# Important Safety Recall 200009

## (NHTSA RECALL NOTICE 20V552)

This recall applies to your trailer mounted boom with the following model(s) and serial numbers:

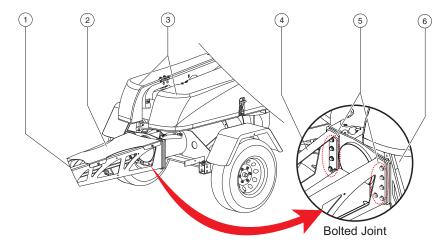
Genie has determined that bolted joint connecting the tongue to the chassis in the machines referenced above may not have been torqued to specifications. Bolted joint not torqued to specifications may come loose and separate from the main chassis. The separation may increase the risk of a crash.

- 1 tongue
- 2 tongue box cover
- 3 turntable covers
- 4 drawbar mount
- 5 retaining fasteners (10X):
  - 6198GT (nut, nylock, 1/2-13)
  - 104235GT (screw, HHC, 1/2-13x2.25 GRD 8)
  - 13066GT (washer, flat, 5 hardened)
- 6 chassis

- 2 Open the turntable covers on both sides of the machine.
- 3 Remove the tongue box cover from the drawbar mount and set aside.
- 4 Torque the retaining fasteners securing the draw bar mount to the chassis.

Torque = 90 ft-lbs / 122 Nm
